FORM 5
ENVIRONMENTAL IMPACT ASSESSMENT ORDINANCE
(CHAPTER 499)
SECTION 13(1)

Application for Variation of an Environmental Permit

C2. Application No. of the Current Environmental Permit : **FEP-218/2023**

**TYPICAL BASE LINER
(INDICATIVE)**

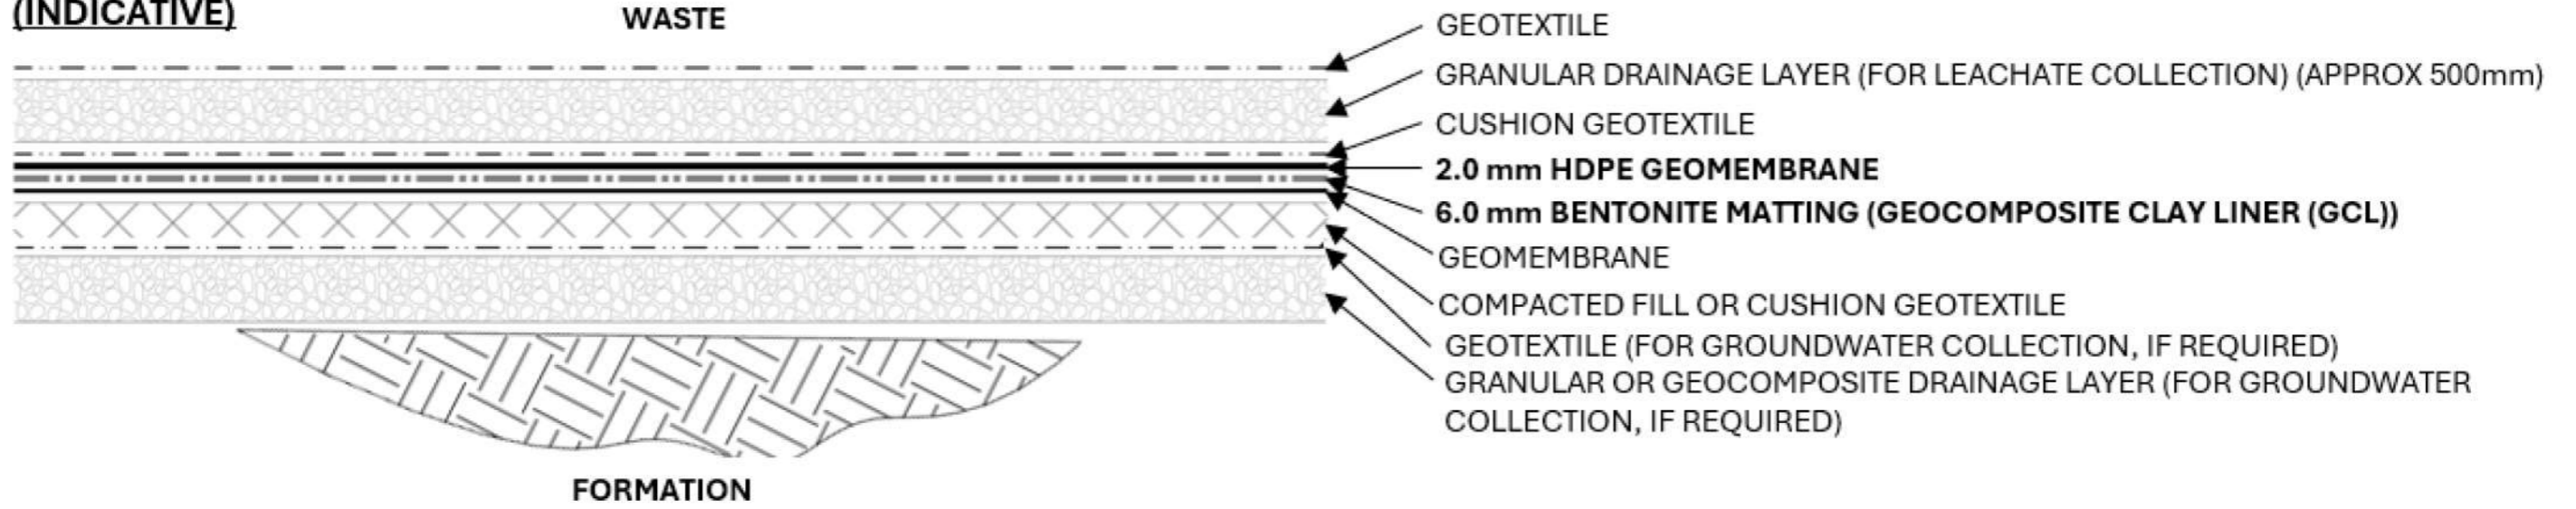
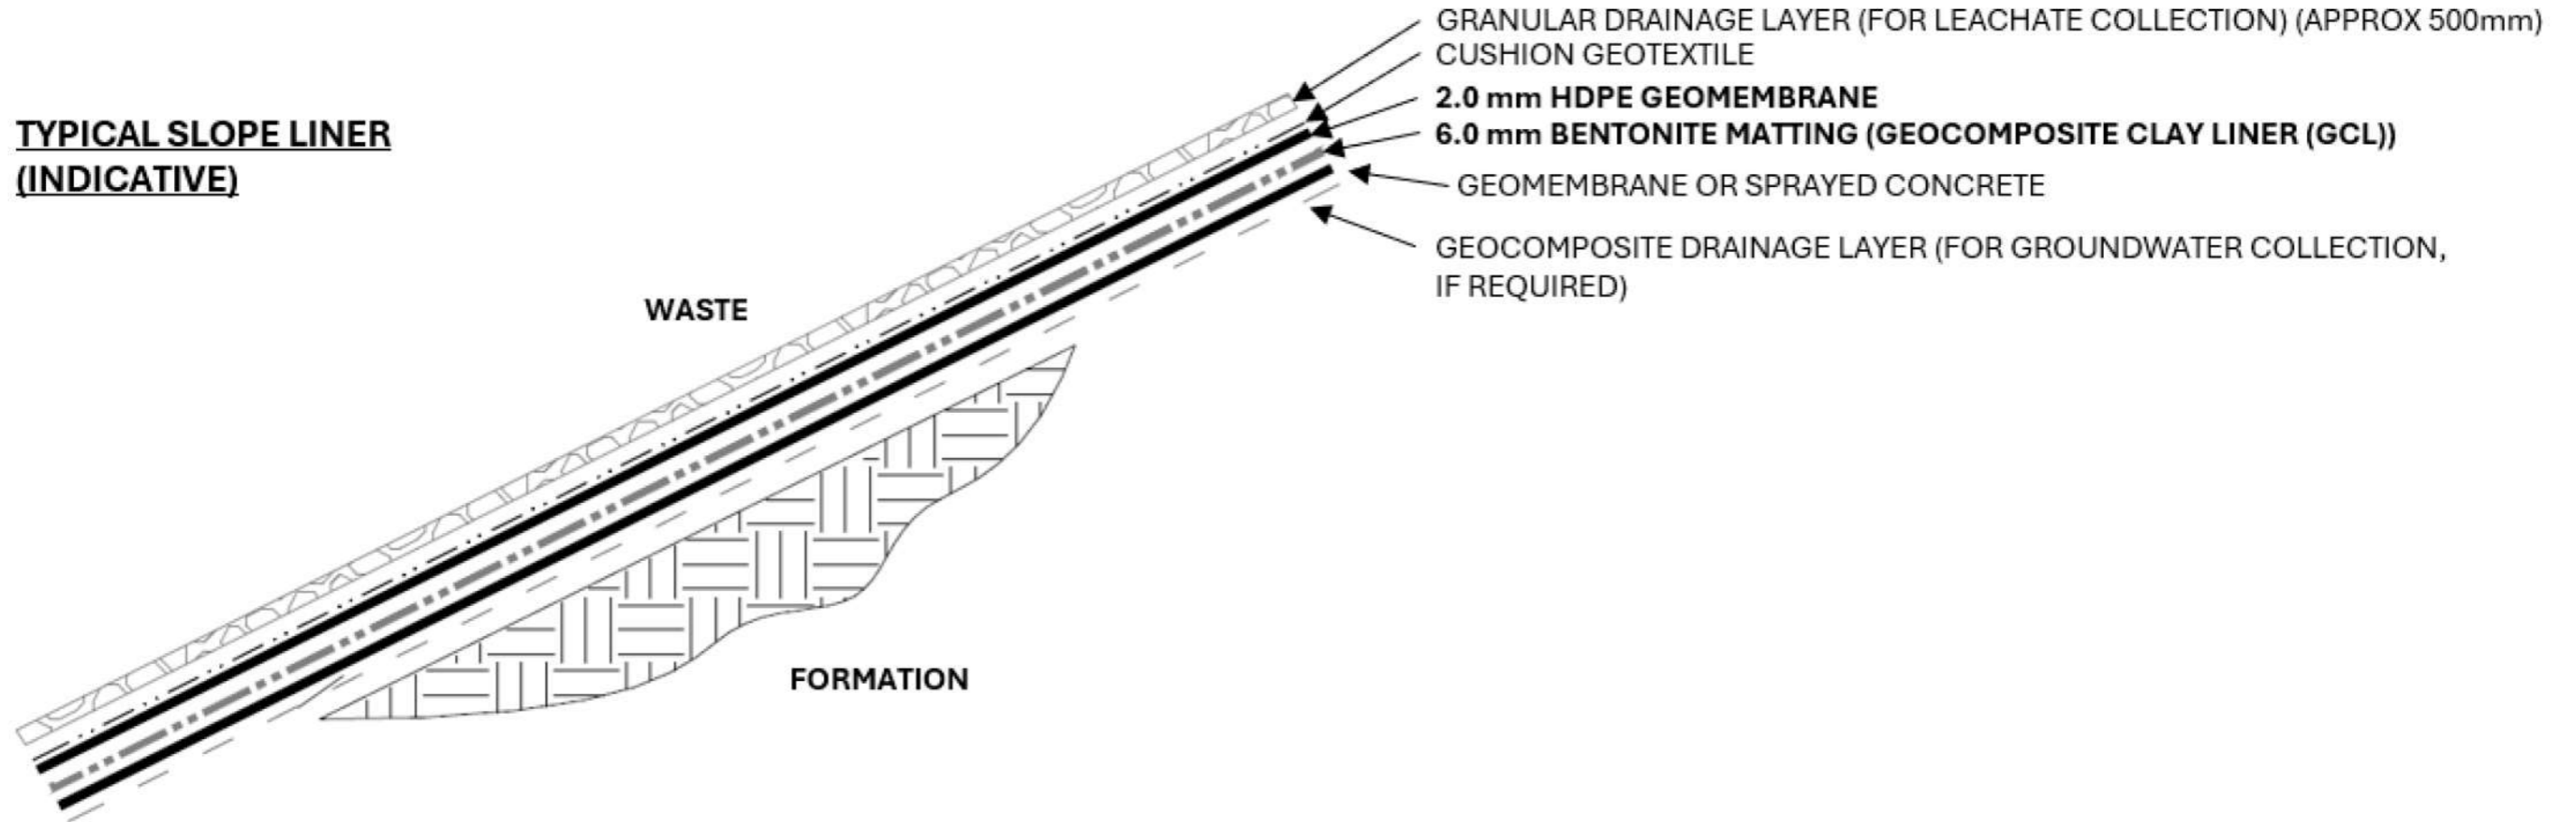
2.4.3 In this connection, in order to properly reflect the latest design of the Multi-layer Composite Liner System for the NENTX Project, it is proposed that a drawing illustrating the typical sections of Multi-layer Composite Liner system could be included into the EP Condition 2.19 (for EP-292/2007) and FEP Condition 2.17 (for FEP-02-292/2007). With an aim to reflecting the latest liner system design of the NENTX Project, the environmental performance requirement set out in the approved EIA Report will not be violated. Prior agreement from EPD should be sought in the event of any variation in the design principle of the Multi-layer Composite Liner system.

| D1. Condition(s) in the Current Environmental Permit : | D2. Proposed Variation(s) : | D3. Reason for Variation(s) : | D4. Describe the environmental changes arising from the proposed variation(s) : | D5. Describe how the environment and the community might be affected by the proposed variation(s) : | D6. Describe how and to what extent the environmental performance requirements set out in the EIA report previously approved or project profile previously submitted for this project may be affected : | D7. Describe any additional measures proposed to eliminate, reduce or control any adverse environmental impact arising from the proposed variation(s) and to meet the requirements in the Technical Memorandum on Environmental Impact Assessment Process : |
|--|--|---|---|---|---|--|
| <p>Part C, Clause 2.17</p> <p>Liner System to Control Seepage of Leachate</p> <p>A composite liner system consisting of a layer of at least 2.0 mm thick high density polyethylene (HDPE) with a hydraulic conductivity of at least 1xE-9 meters per second and a layer of at least 6.0 mm thick bentonite matting with a hydraulic conductivity of at least 1xE-11 meters per second shall be provided over the entire area of the Project.</p> <p>在整個工程項目範圍內需鋪設組合防漏墊層系統，其中包括一層最少為2.0毫米厚的高密度聚乙稀，其水力傳導性最多為每秒1xE-9米，以及一層最少為6.0毫米厚的膨潤土墊，其水力傳道性最多為每秒1xE-11米。</p> | <p>Part C, Clause 2.17 and a new Figure 4 attached in ERR.</p> <p>Liner System to Control Seepage of Leachate</p> <p>A Multi-layer Composite Liner System shall be provided in accordance with Figure 4 covering the entire area of the Project where waste will be deposited.</p> <p>須按圖4所示設置一套多層合成墊層系統，覆蓋工程項目用作棄置廢物的全部範圍。</p> | <p>The variation is to reflect the contemporary landfill design of the multi-layer composite liner system, ensuring the engineering performance of the NENT Landfill Extension for protection of the surrounding environment.</p> | <p>No adverse environmental impacts are anticipated from the proposed variation. For details, please refer to the attached ERR.</p> | <p>The environmental and the community will not be affected by the proposed variation. For details, please refer to the attached ERR.</p> | <p>The environmental performance requirements set out in the EIA report previously approved for this project will not be affected by the proposed variation. For the details, please refer to the attached ERR.</p> | <p>No additional measure is required.</p> |
